ENGINEER'S DRAINAGE REPORT

GLENWOOD VILLAGE
NORTHEAST CORNER
MONTGOMERY AND TRAMWAY

CITY OF ALBUQUERQUE
HYDROLOGY SECTION
FILE: F23/D4

FEBRUARY 1988
(87-520A)

DESIGN **TEB**
DRAWN **JEC**
DATE **REVISED JUNE 88**
FILE NO. **87-520A**
SHEET NO. **7**

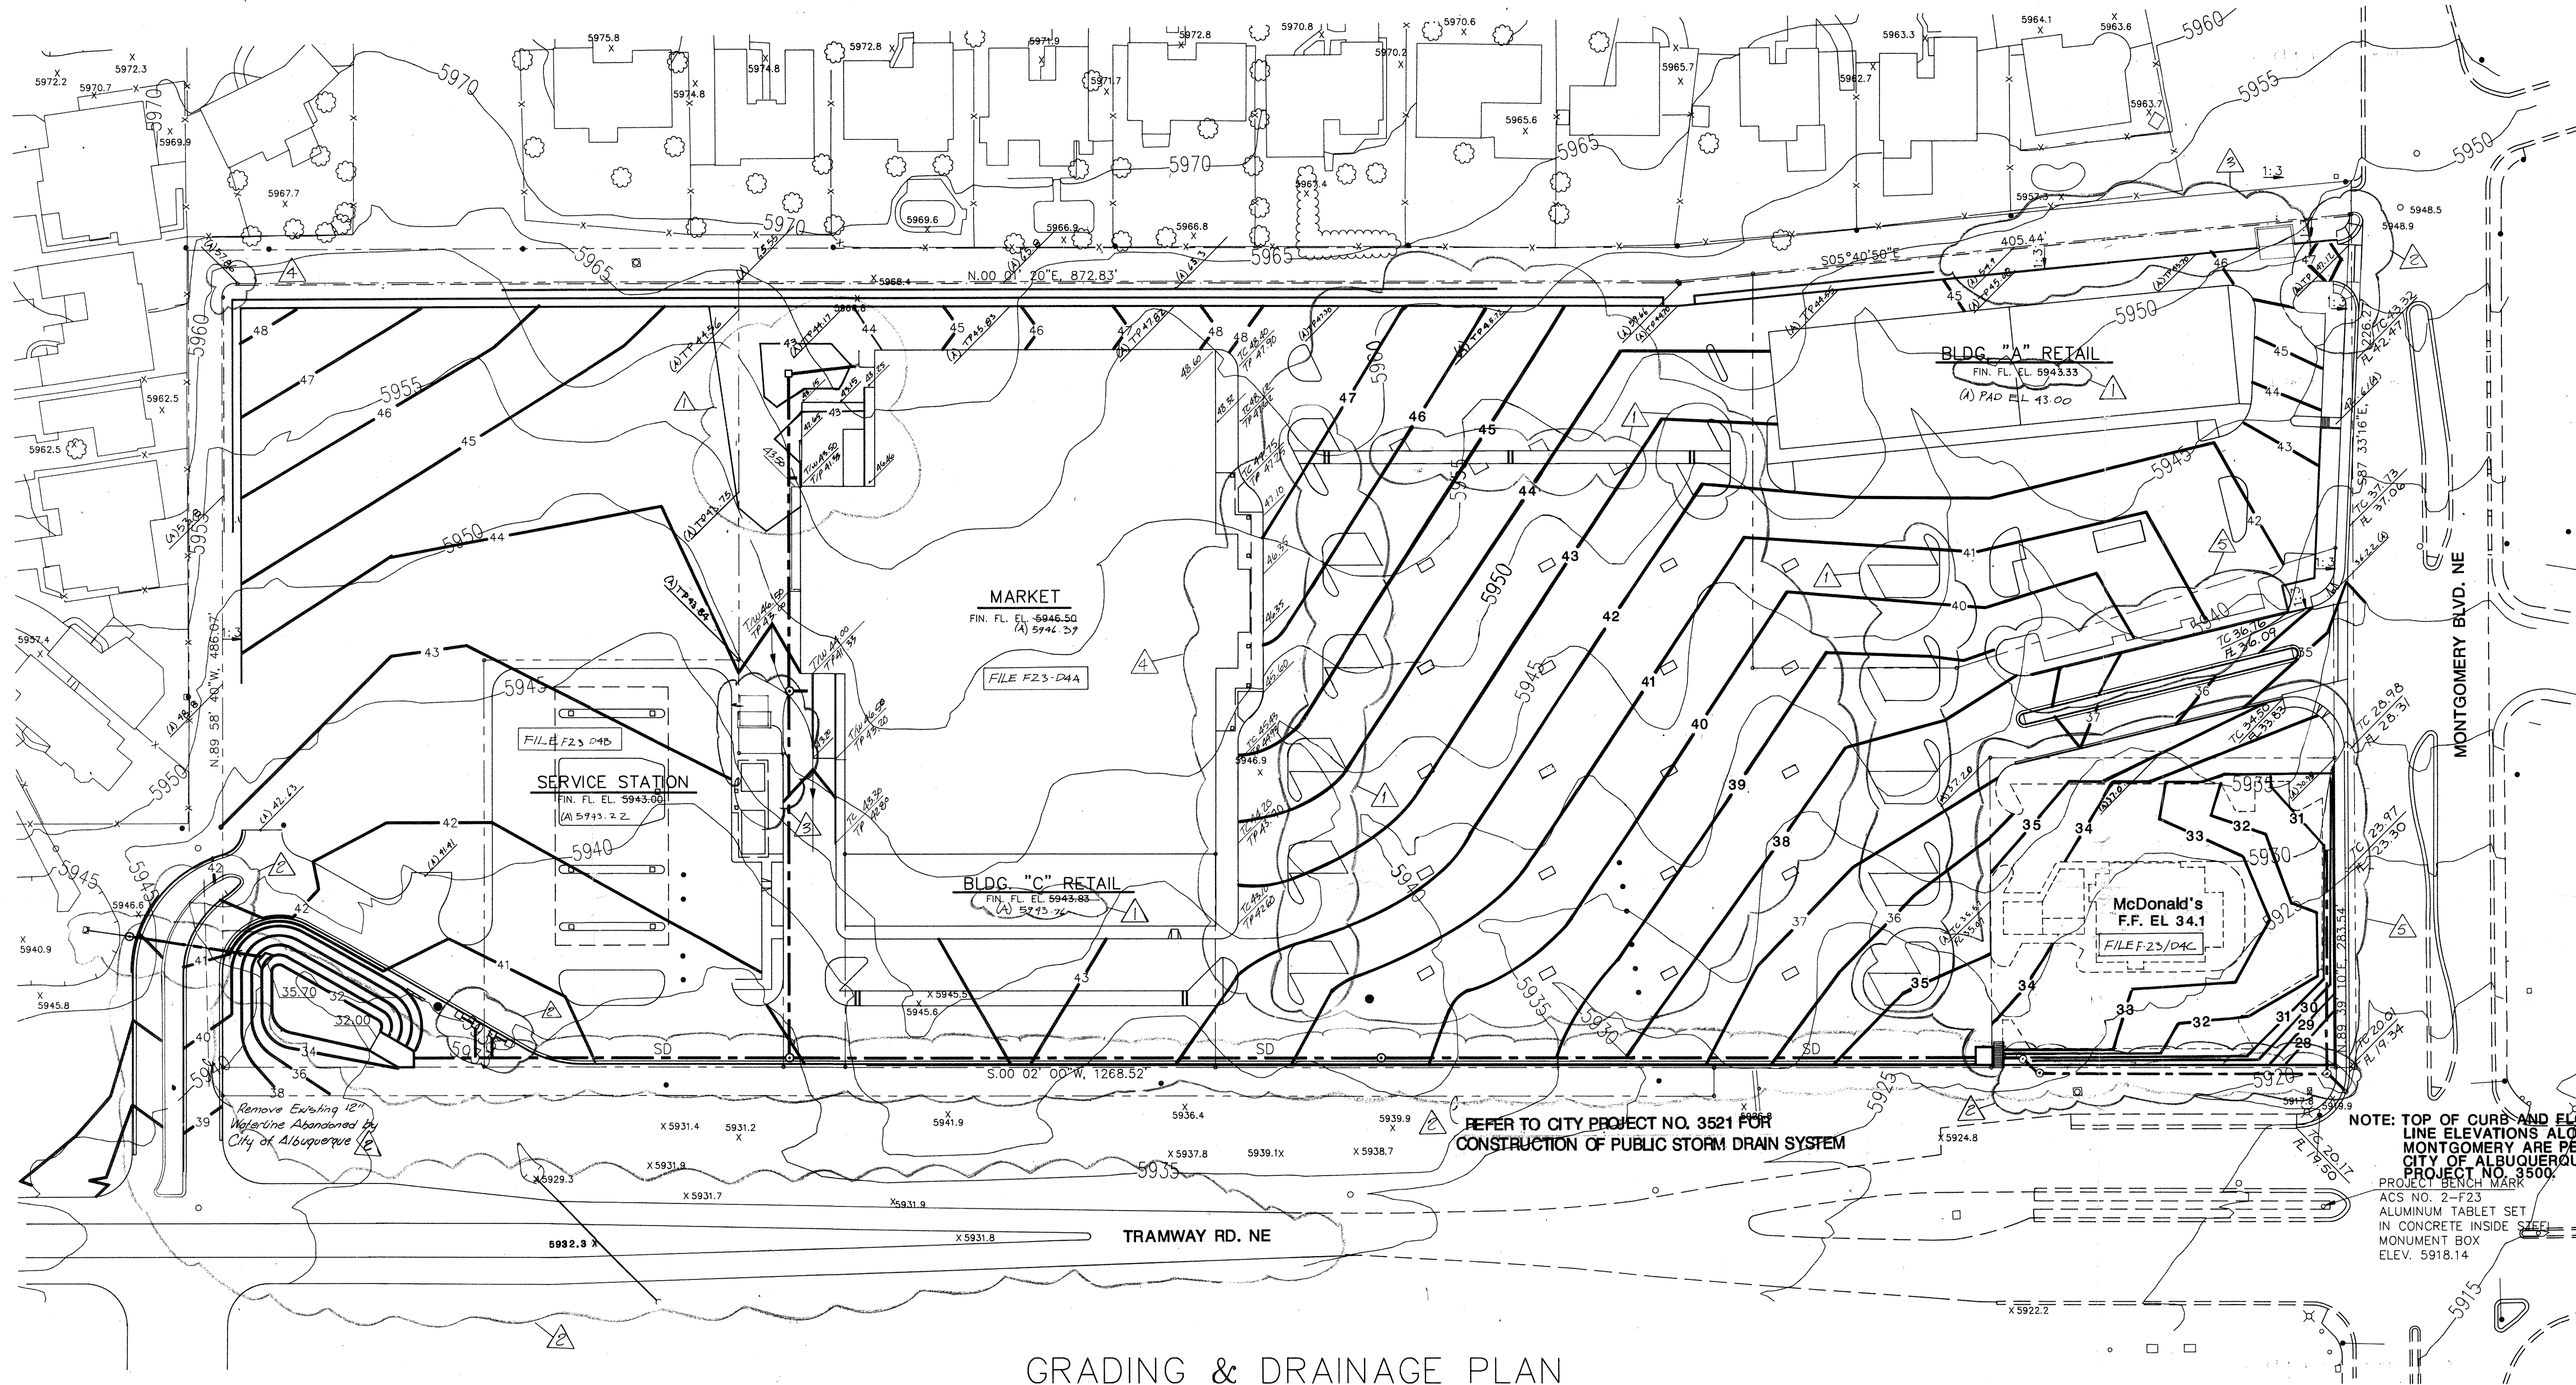
1. Pages 16 and 17 of the Report - it is not clear where your Q_{100} values are from. The storm drain laterals should carry the basin peak flow rate unless the parking areas are also to be used as ponding areas. Also include the catch basin designs and inlet capacity calculations for all the inlets in conjunction with page 18.
2. Sheet 6 and 9 - it is not clear where the B/W elevation applies on Sheet 6, Section 7-6; is it the finish grade point or bottom of wall on top of the box culvert?
3. Sheet 7 - show the drainage easements and label as Public or Private as required.
4. Sheet 7 and 9 - more spot elevations are required along the west property line and Tramway Boulevard showing how the finish grade at base of retaining wall will interface with future sidewalk and right-of-way line. It appears a steep slope will result, therefore what slope treatment will be required?

2. The bottom of wall elevations on Sheet 9 refer to the finish grade. this is noted in the legend on Sheet 9.
3. A revised Sheet 7 is enclosed showing proposed drainage easements.
